RECOMMENDATION MEETING

3606 WOODLAND PARK AVE N

A Proposed Apartment Development
for GRE Fremont L.L.C.
July 25, 2011

PRIORITIES & BOARD RECOMMENDATIONS FROM INITIAL RECOMMENDATION MEETING

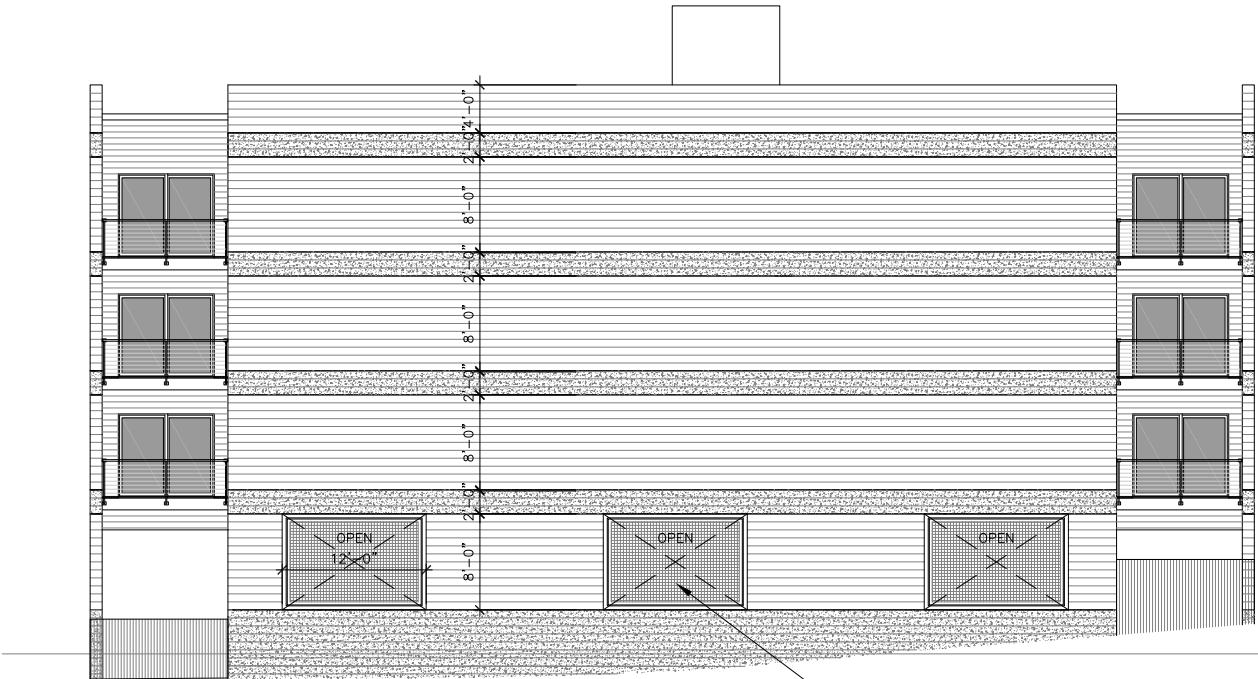
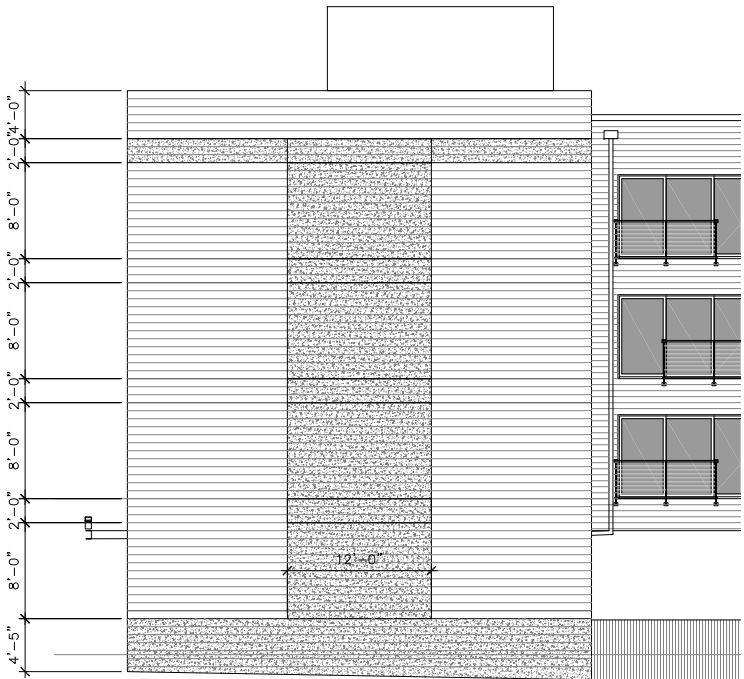
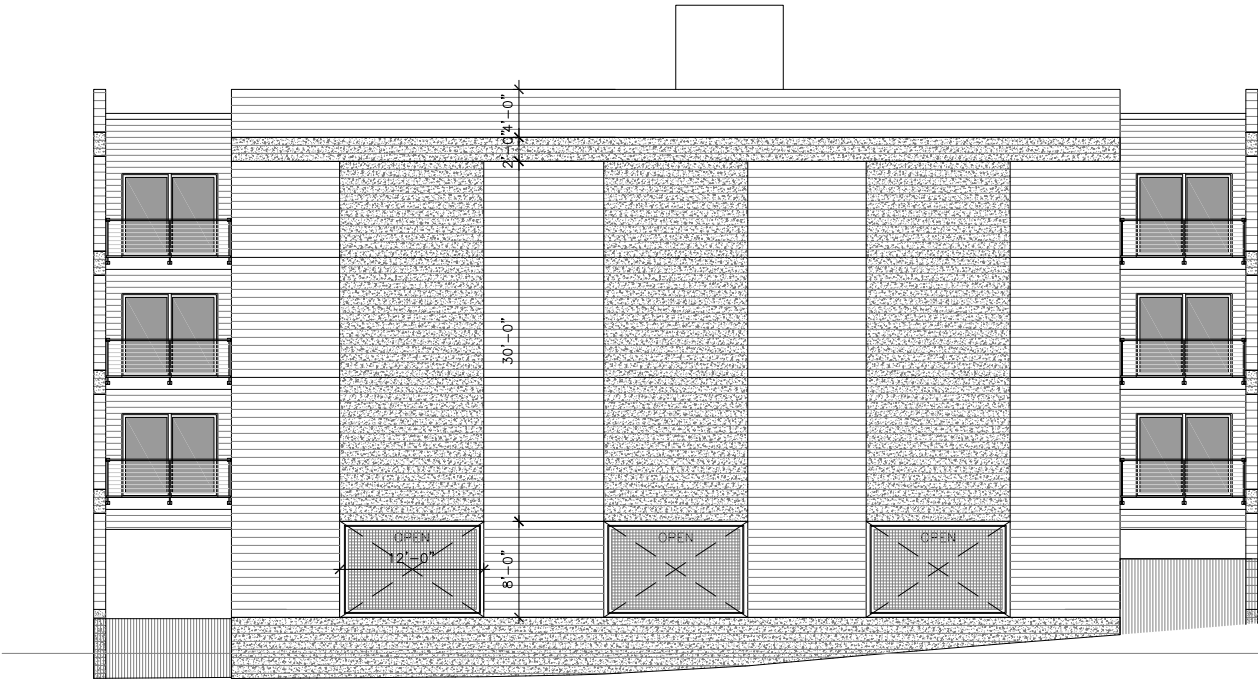
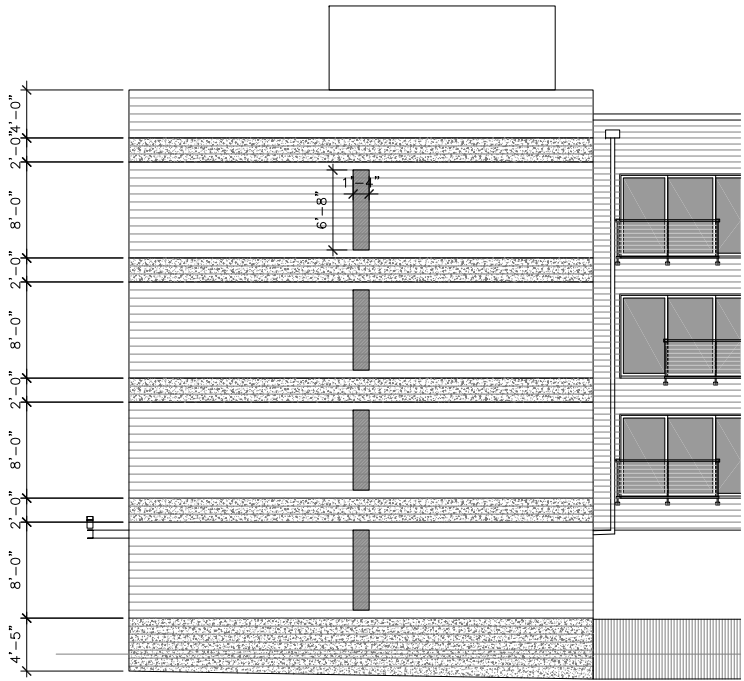
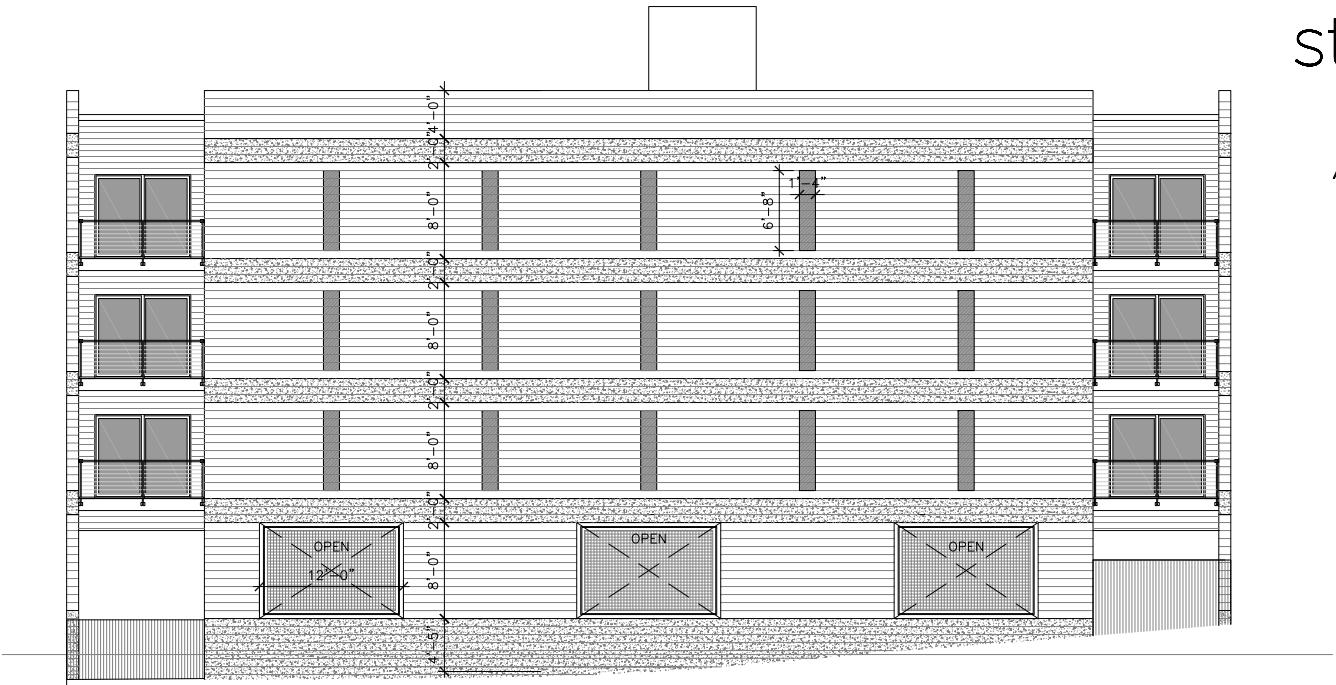
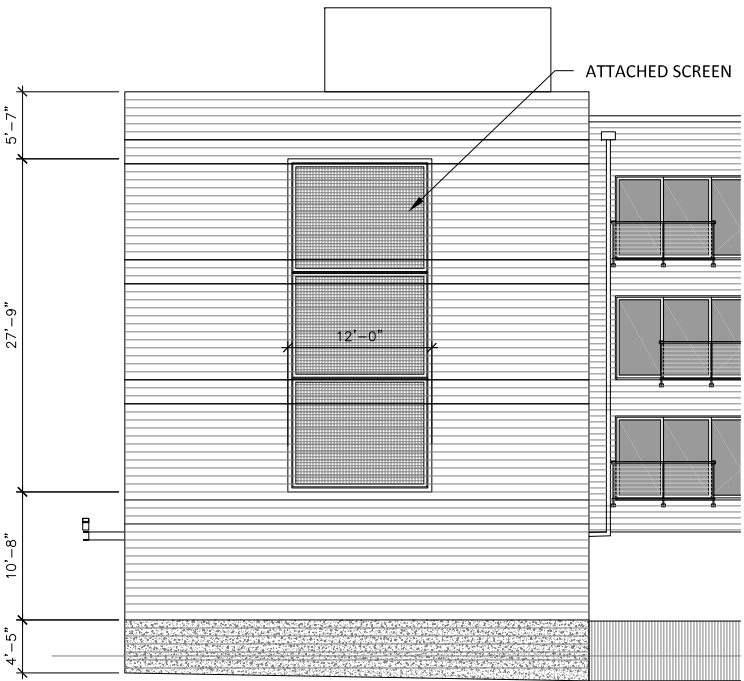
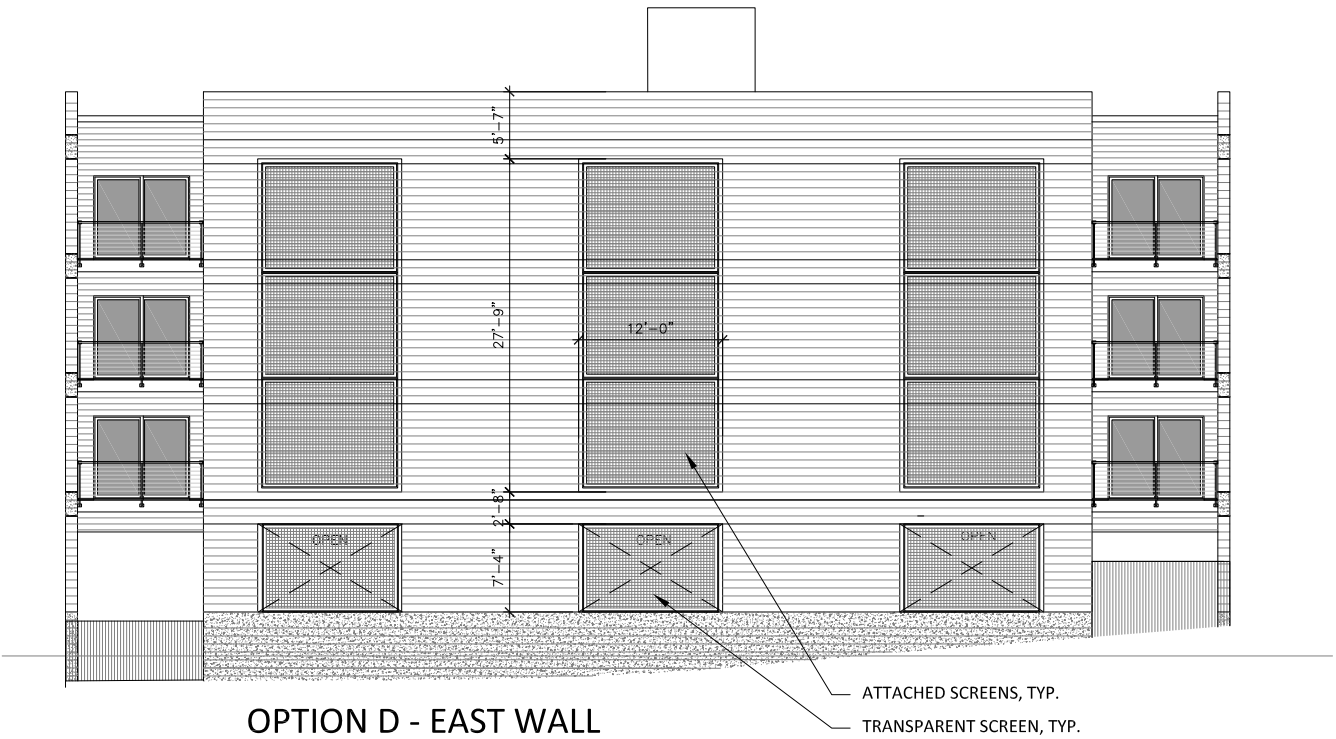
The Board noted that the four story blank wall at the east façade is a particular concern, and banded CMU materials may not be sufficient to meet this guideline. Mitigation of this four story blank wall is important because it is highly visible to pedestrians at Stone Way North, across the open bank parking lot. Detailed information about the proposed materials (coursing, finishes, etc.) is needed to determine whether the proposal meets this guideline. The applicant should consider the use of additional treatments, such as a planted area with vines.

The Board was unable to comment on the potential blank wall issues at the north and south facades because of the lack of information. The applicant should provide detailed and overall information to demonstrate the proposed design of these facades, including fences, landscaping, materials, and modulation.
7. Personal Safety and Security

OPTION A - TYPICAL SIDE WALL

OPTION A - EAST WALL

OPTION B - TYPICAL SIDE WALL

OPTION B - EAST WALL

OPTION C - TYPICAL SIDE WALL

OPTION C - EAST WALL

OPTION D - TYPICAL SIDE WALL

PARKING / SECURITY SCREENING

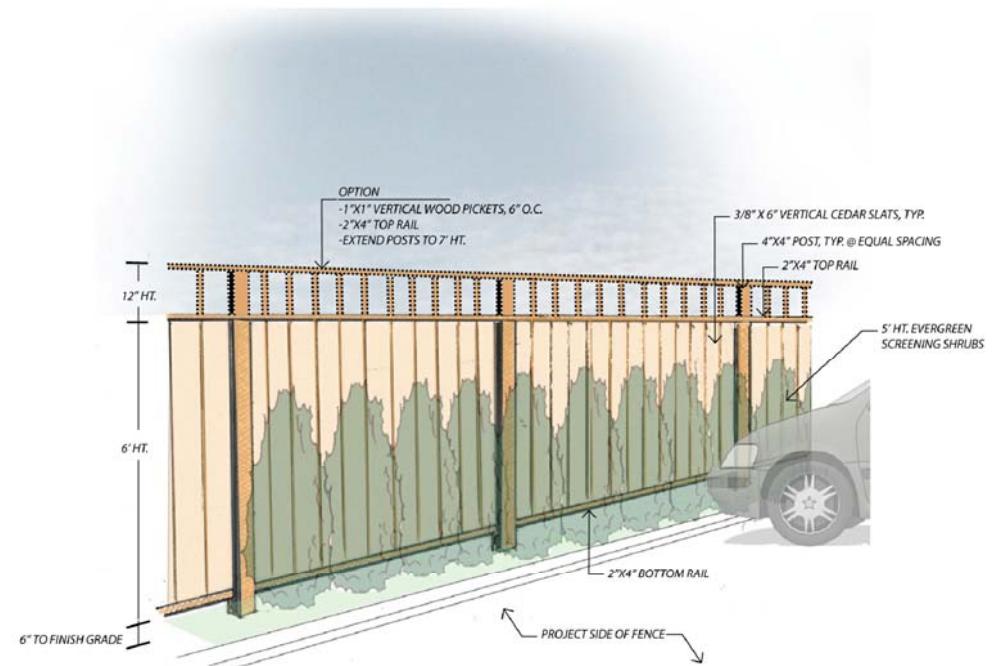
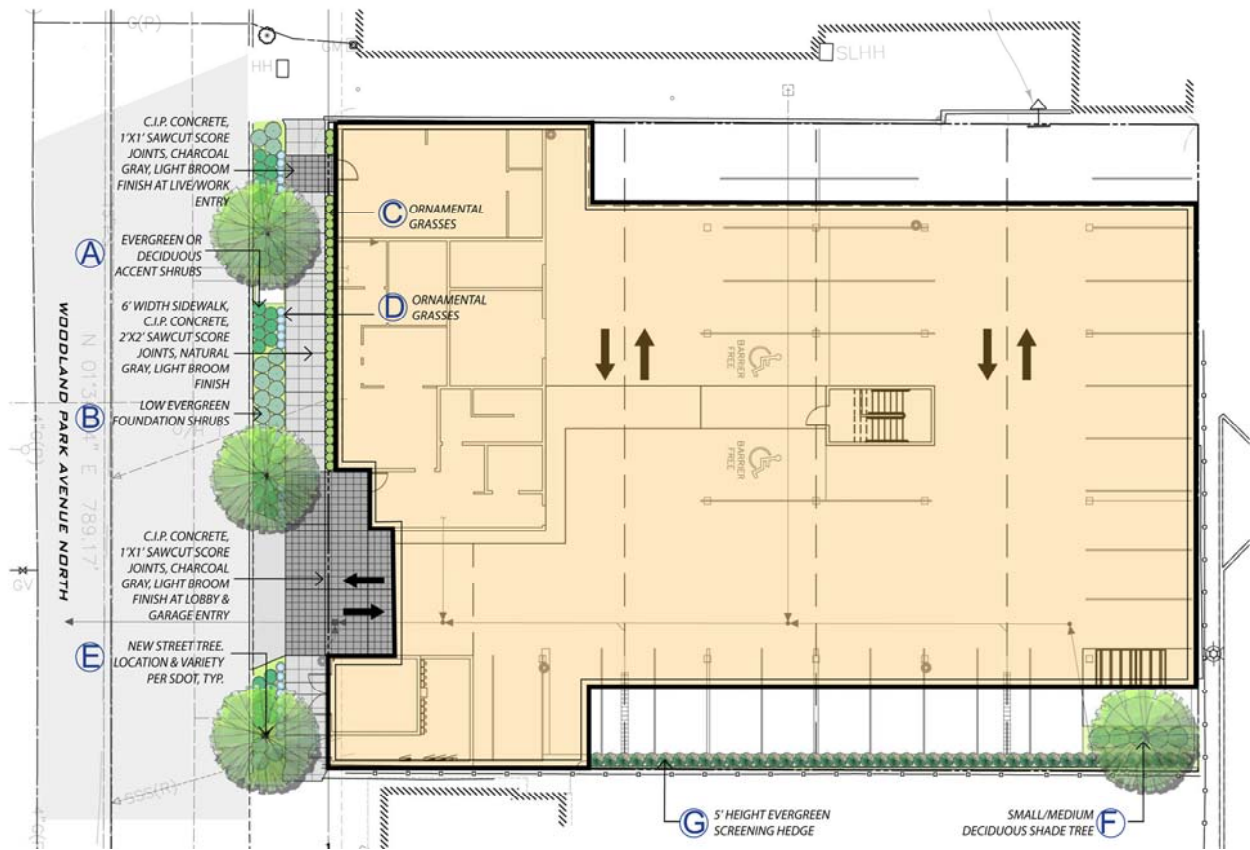
At the Initial Recommendation Meeting, the Board noted that the proposed parking lot design seems to raise safety and security concerns, given the partially open design that could allow access over 5’ fences, but without the safety of “eyes on the street” in the parking area.

The Board didn’t have enough information about the proposed screening and accessibility of the parking to make a recommendation about this item. The applicant should return with information that demonstrates how the proposed design meets this guideline.
9. Commercial Signage:

- BLUE DOTTED LINE INDICATES:
LOCKING, METAL OVERHEAD COILING
DOOR AT PARKING ENTRY / EXIT
- ENTRY TO BUILDING REQUIRES
KEY CARD FOR TENANTS AND
TELECOM CALL-BOX FOR GUESTS
- ABUNDANCE OF EXTERIOR LIGHTING
AROUND ALL SIDES OF BUILDING
- GREEN LINES INDICATE:
TALL ARCHITECTURAL FENCE AT
GROUND LEVEL PROPERTY LINE
(SIMILAR TO THAT SHOWN BELOW)

LANDSCAPE GROUND FLOOR PLAN

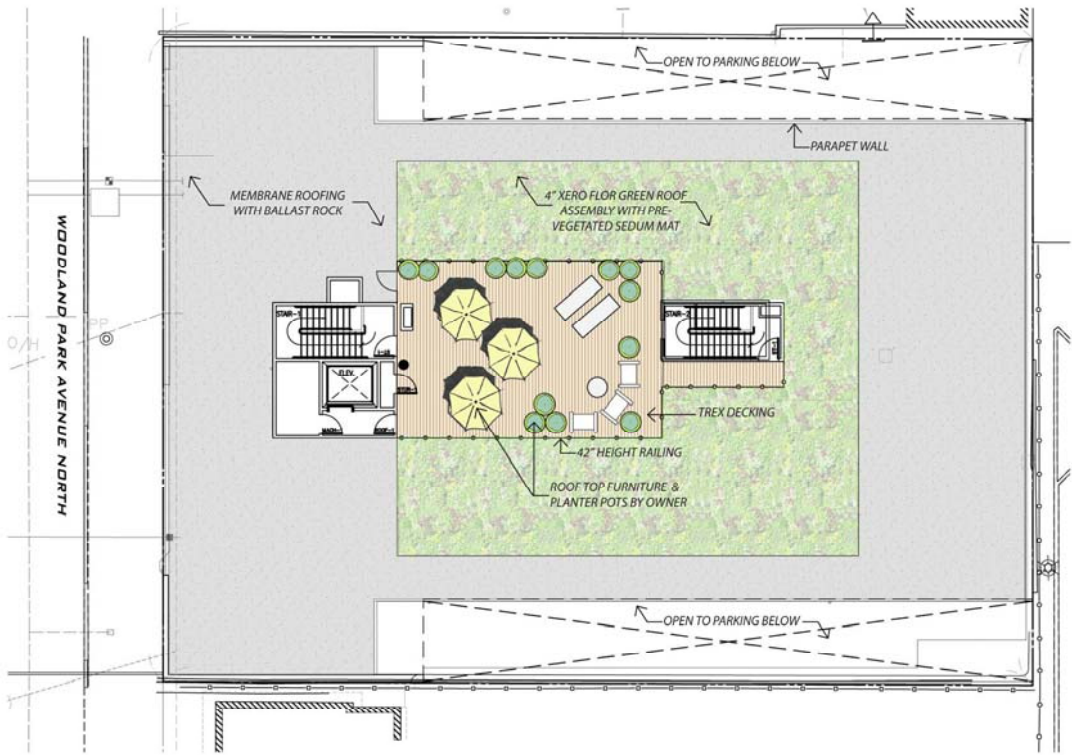
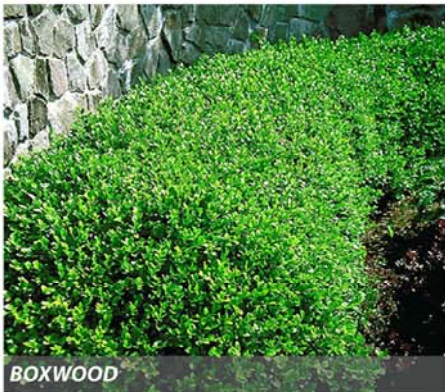
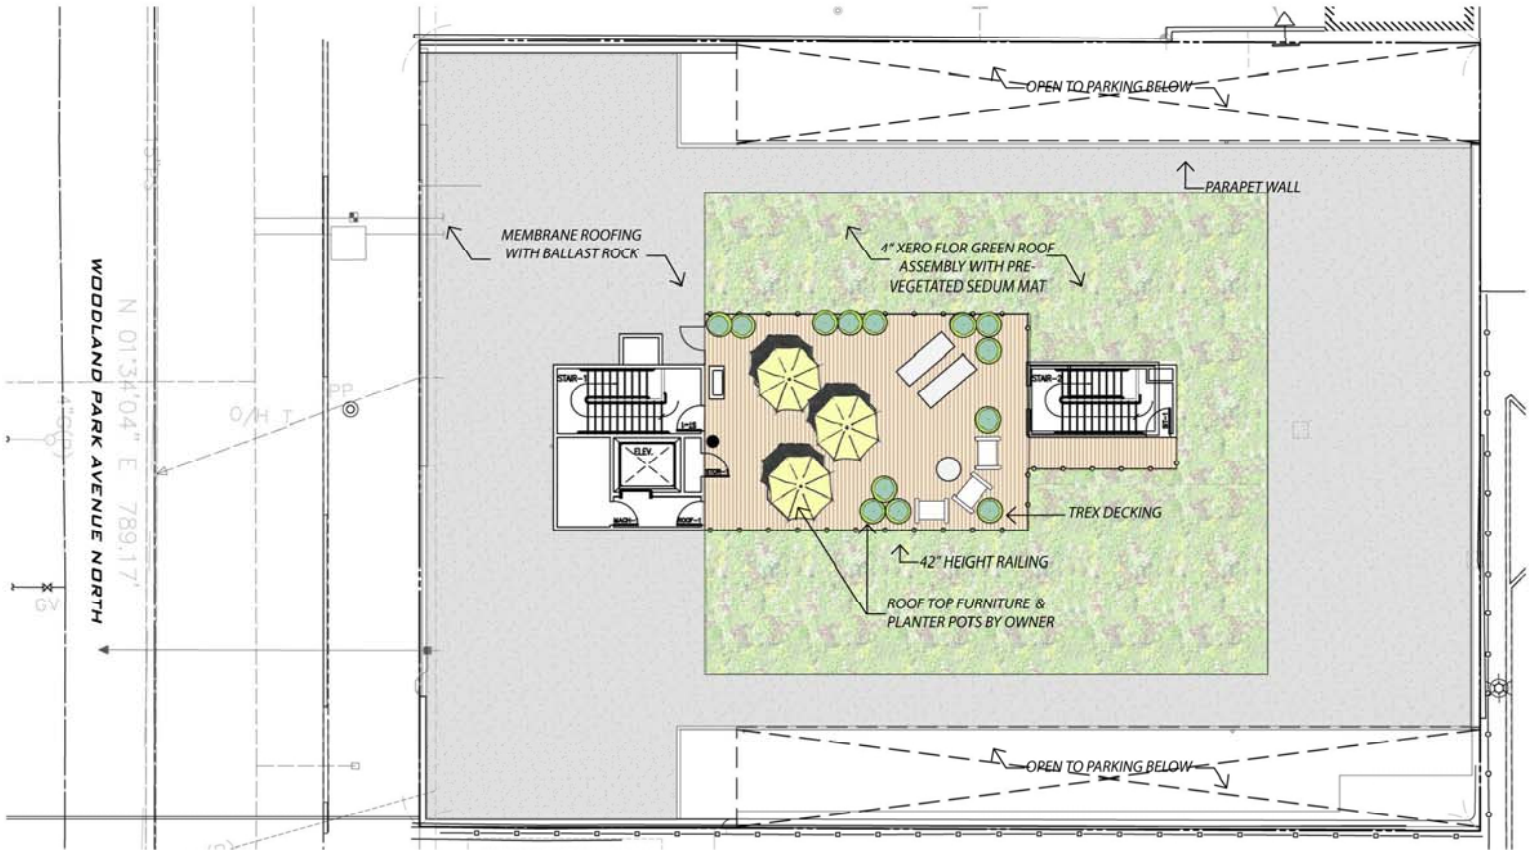
At the Initial Recommendation Meeting, the Board reiterated the guidance from EDG, and noted that the proposed landscape plan should demonstrate the details of the proposed planters at the west building façade, and any proposed landscape screening at the north/south facades. The Board recommended additional landscape screening at the north and east facades, and above the parking area.
